**STAFF REPORT  
FOR THE HISTORIC REVIEW BOARD**

**FILE NUMBER:** DR-18-02

**REQUEST:** Class I Design Review – Modify window configurations, as approved in July 2016 (DR-16-01), on north, east, and south building elevations and a variance for siding material

# PROPOSED ALTERATION OF NORTH ELEVATION

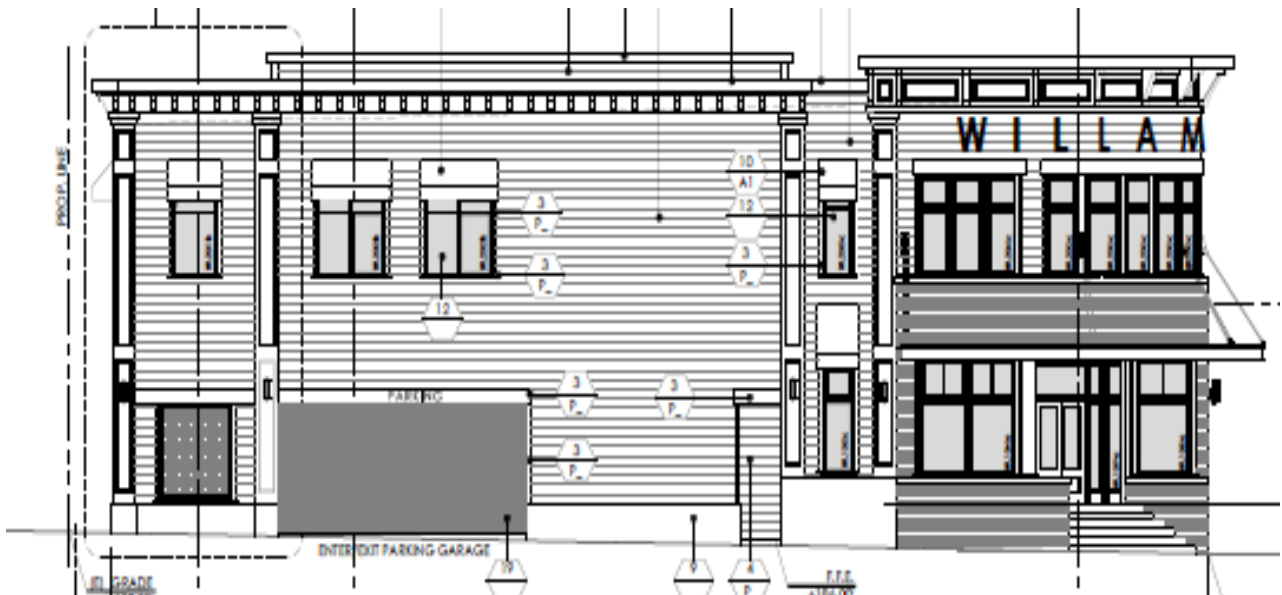
The applicant was approved to construct this commercial building per DR-16-01 approval. After HRB approvals were obtained, full architectural and structural engineering plans were produced in preparation for construction and building permits. During the structural design of the building, engineering conflicts became apparent with some of the prior approved window locations and configurations.
